Interdepartmental Memo

To: Members of the Common Council
From: Jacqueline Scanlan, AICP Development Services Manager
Subject: PUD-18-23 Summit PUD
Date: March 28, 2024

REQUEST: The petitioner is requesting to rezone approximately 140 acres to Planned Unit Development and a request for approval of a District Ordinance and Preliminary Plan.

Image Six: PUD Designation Map

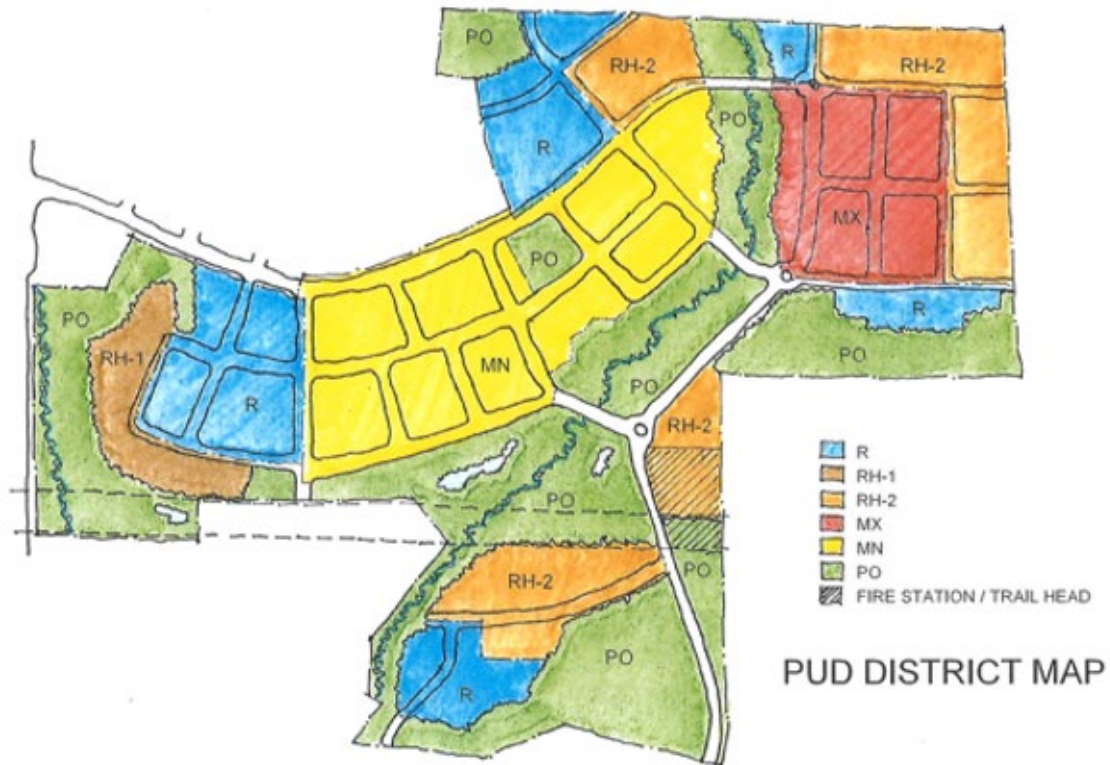
The petitioner is proposing to utilize the six zoning designations across the site, as seen in Image Six, below, from the District Ordinance.

Image Eight: Transportation Plan Connections on Aerial of Site

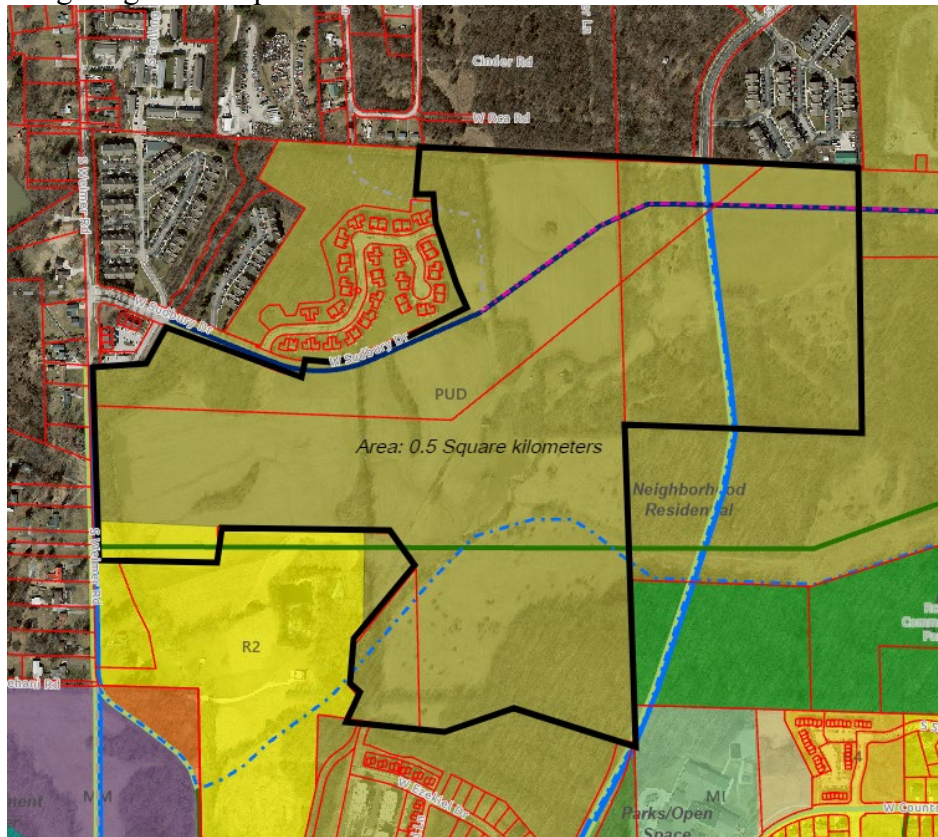
Right-of-Way Connection: As can be seen in Image Seven below, the petition site, outlined in black, has a number of improvements in the adopted Transportation Plan. The northernmost connection is the extension of Sudbury as a General Urban street from the end of the existing W. Sudbury Drive right-of-way to the eastern end of the petition site. (NC-19) That roadway is proposed to contain a protected bike lane. On the eastern side of the petition site, S. Adams Street stubs at both the north and south ends of the petition site, and the Transportation Plan shows a Neighborhood Connector with bike lanes and sidewalks. (NC-20) The petitioner is including the entirety of the Adams Street connection on their parcel and has worked with the Department and the Engineering Department on a general location, as can be seen in the Preliminary Plan maps. There is a third new right-of-way shown in the Transportation Plan on the southern end of the petition site. (NC-24) That road is shown as a Neighborhood Connector that appears to be aligned with the Duke Energy easement to the east, and moves southwest to connect to the existing Weimer Road right-of-way through a neighboring parcel. It has been determined that because of changes to the east of this site, an eastern connection of NC-24 is unlikely and this PUD will not plan for that connection. A condition of approval has been added. Additionally, NC-24 will curve south and connect to the existing ROW for Breaking A Way with a stub to the west for a possible future

connection to Wapehani and Weimer Roads. In that way, NC-24 will provide immediate connection to the south, but leave open the possibility of vehicular connection to the intersection of Wapehani and Weimer Roads in the future.

10. The PUD allows that the eastern leg of NC-24 from the Transportation Plan will not be platted or built.

Image Nine: Mobility Map

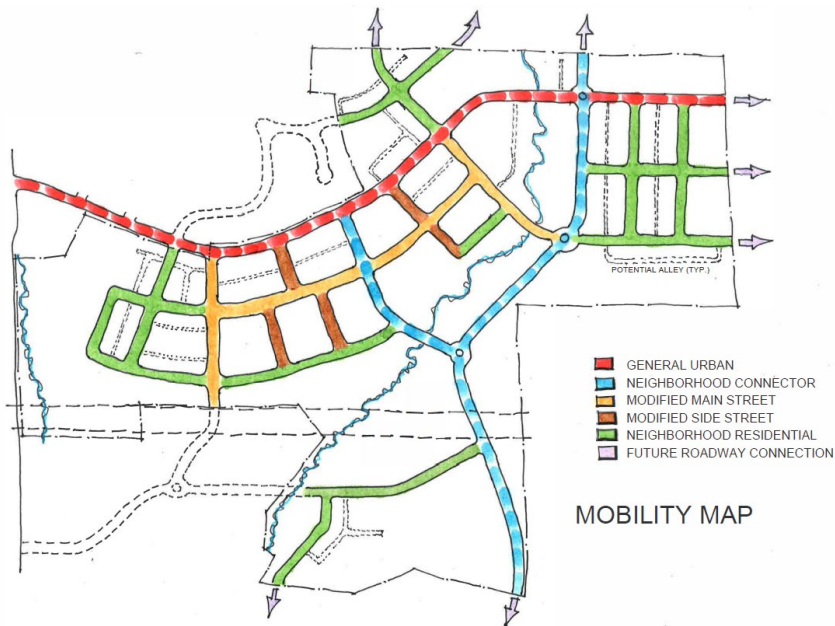
Image Nine below from the Preliminary Plan shows two stub streets that could be extended in the event that the property to the southwest of the site is every developed beyond its current condition. This petition in no way requires or makes that development happen. Considering potential future connection through that property is prudent because of where Weimer Road intersects with Wapehani Road.

The remainder of the site, as can be seen in Image Nine above, includes various right-of-way connections for vehicular travel. Two additional stubs are included to the north for potential future connection, as well as three to the east, stubbing to the Monroe County Government-owned property. The petitioner has made an effort to increase the gridded nature of most of the property, within the confines of the existing environmental conditions. The connection of Adams Street, and preparation for a potential future Sudbury Drive connection east to Strong Drive provide important additional roadway options for all city roadway users.
